Planning Report

City of Verona

Epic – Workshop

Site Plan and Conditional Use Permit

Figure 2 - Drone view with photo rendering showing the Workshop to the left and the Annex in the center

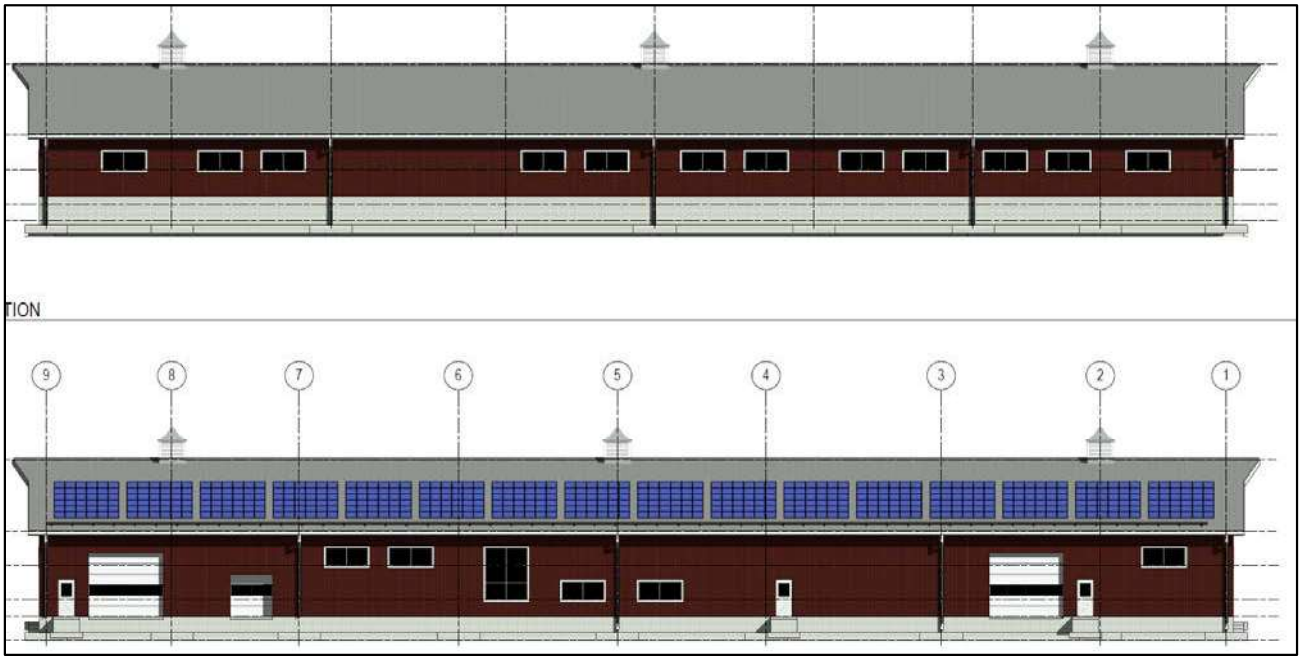
Architecture:
The proposed Workshop is a similar design and color to the existing Contractor Annex building and the Vehicle Fleet Maintenance Workshop nearby as depicted in Figure 2. The building will consist of a premanufactured red metal building with solar panels to match the other structures in the area as depicted in Figure 3. The building contains windows to allow natural light to enter the Workshop. Staff has no concerns with the design of the buildings.

SITE PHOTOMETRICS

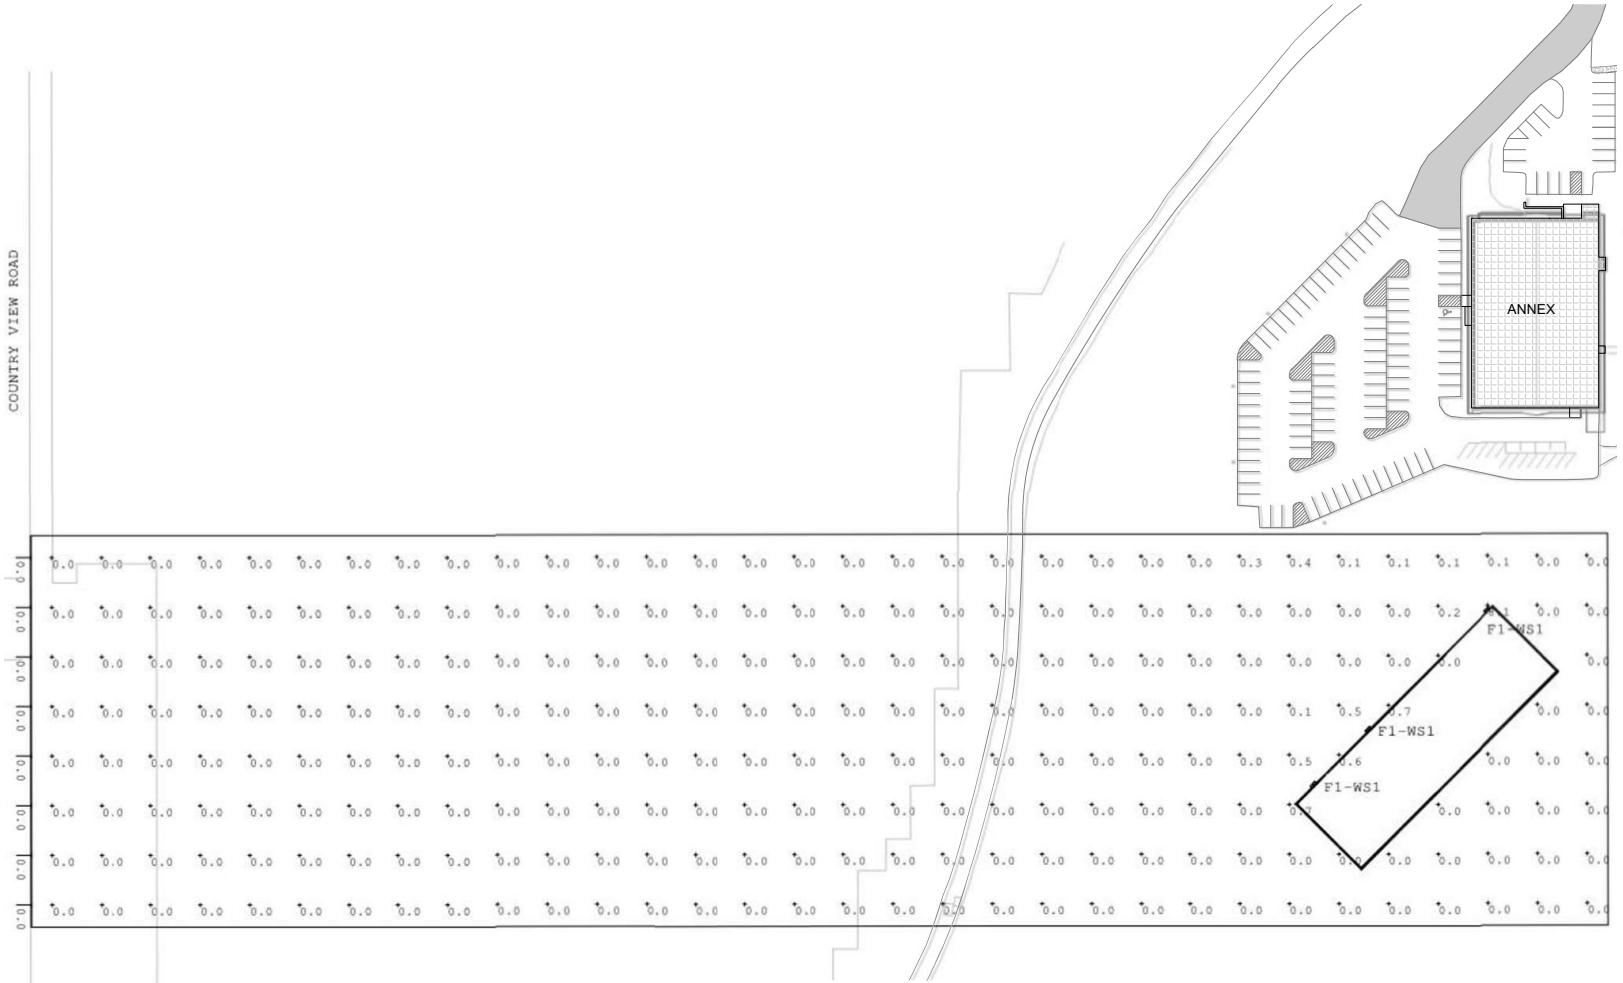
A lighting plan was submitted as part of the Application. All lighting is within the acceptable range for the Property. The lighting does not affect the neighboring properties as it is 0 footcandles at the property lines, while the zoning ordinance allows 0.4 footcandles at the property lines. Staff has no concerns with the lighting.
